Item 5.**326-328 Botany Road, Alexandria - D/2019/657****File No.: D/2019/657****Summary**

Proposal Summary: Proposal

The subject application seeks consent for a concept building envelope incorporating commercial uses. The proposal includes:

Figure 33: Envelope - south elevation illustrating minor height non-compliance.

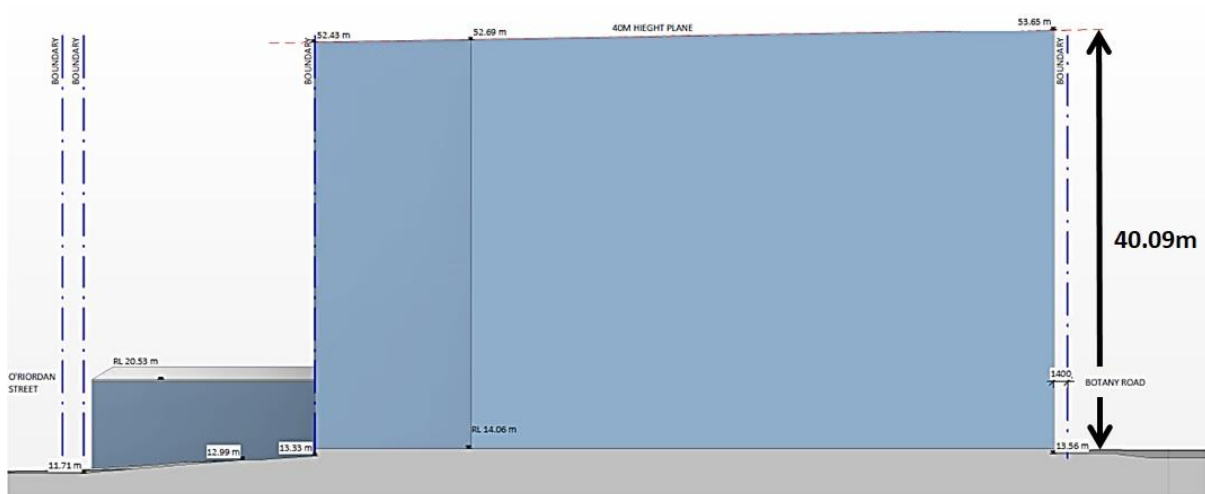
34. A maximum height of 40m is permitted. At its south-eastern corner the height of the proposed envelope is RL 53.65 and which is 40.09m above the ground level (RL 13.56), as shown in **Figure 33** below.

35. A condition is recommended for:

Figure 34: Reference scheme (ground level) incorporated a TSL prior to the current iteration of amendments.

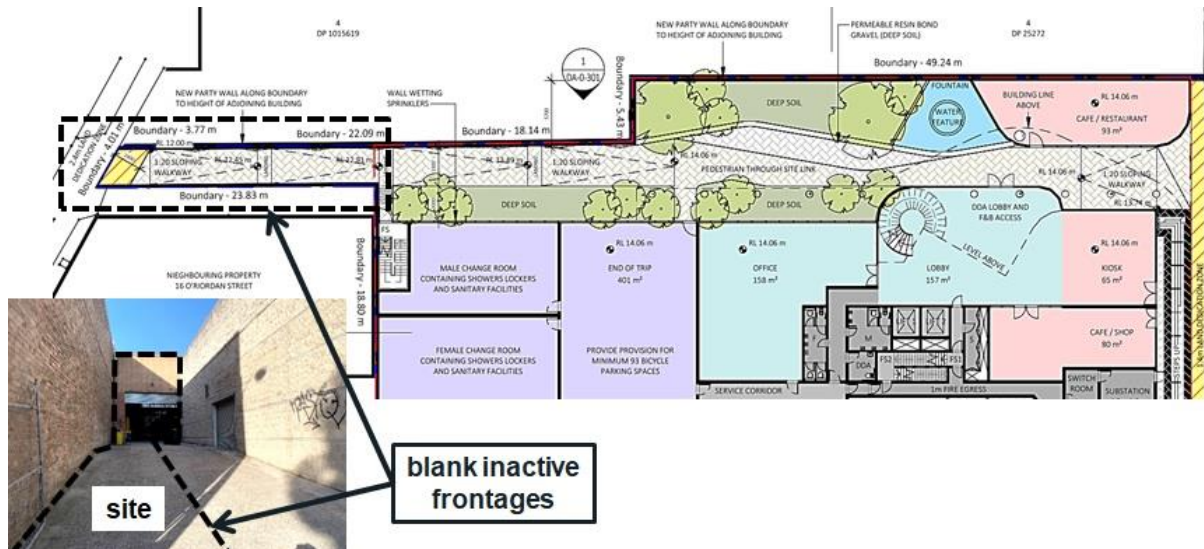
40. As noted in the section of this report titled History of the Subject Development Application (paragraphs 14 to 17), the proposed concept DA was presented to DAP in September 2019. While the concept envelope presented to DAP did not prescribe a through-site link (TSL), the provision of a TSL had informed the reference scheme (refer to **Figure 34** below) and other aspects of the proposal such as the landscape concept plan.

41. The DCP does not identify the site as being required to provide a TSL. Fifty metres to the north along O’Riordan Street is the proposed location of a new public plaza currently known as Transport Place. Transport Place will be a new transport hub associated with the existing Green Square train station. Approximately 110m to the south, is a proposed new east-west street to connect the Green Square Town Centre to O’Riordan Street and beyond. For these reasons it is considered that a TSL is not required in the location of the subject site to increasing permeability through the block.

43. The amended DA package submitted 30 October 2019 included an amended reference scheme which deleted the portion of the through site link circled in **Figure 34** above, and which is a narrow piece of land that connects the site to O’Riordan Street, currently comprising a driveway.

44. To provide clarity to architectural firms participating in the competitive design process, a condition is recommended to be included in the design requirements of any competitive design process brief, that a through site link must not be provided on this site.

Figure 37: Envelope plan relative to adjacent hotel light-wells at 16 O'Riordan Street.

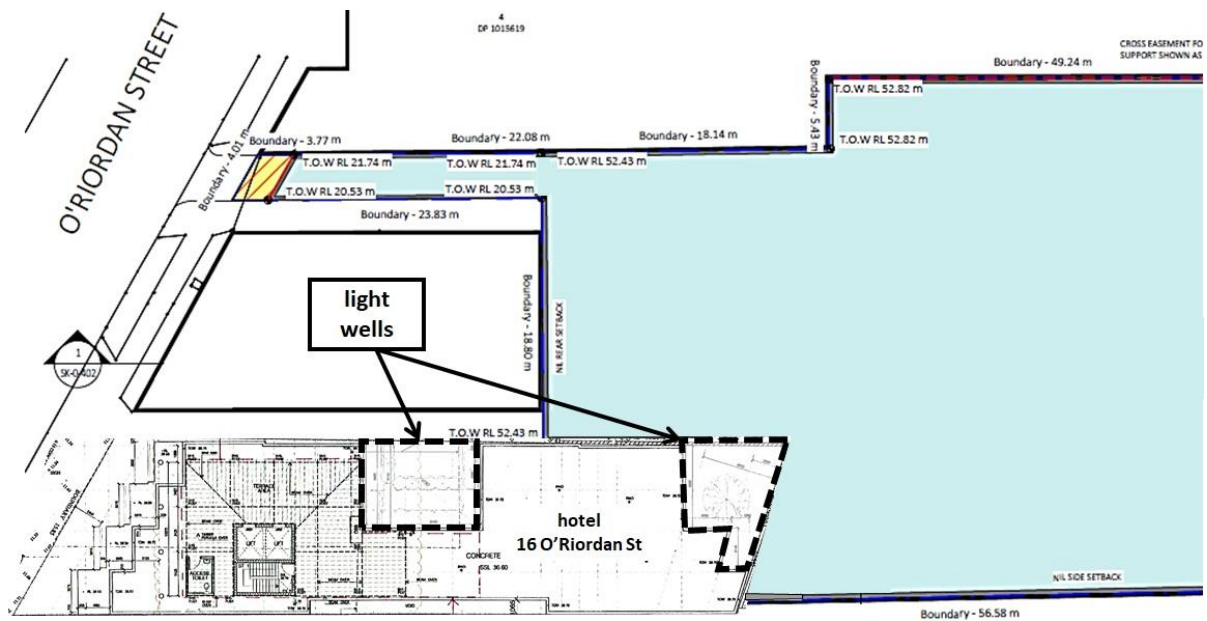
46. The reference scheme demonstrates that this simplified or 'loose-fit' envelope will provide some flexibility as to how floor space may be configured on the site in the competitive design process.
47. As the DCP does not prescribe side or rear boundary setbacks it will be up to the competing architects' designs to respond to contextual matters in this regard, such as to provide natural light / ventilation to or separation from windows on adjacent sites (such as existing windows to the small light well at the eastern end of the hotel development at 16 O'Riordan Street shown in **Figure 35** below).

48. A condition is recommended for side and rear building setbacks to respond to the surrounding context including to provide natural light / ventilation to or separation from windows on adjacent sites, to be included as design requirements to be incorporated into any future competitive design process brief.
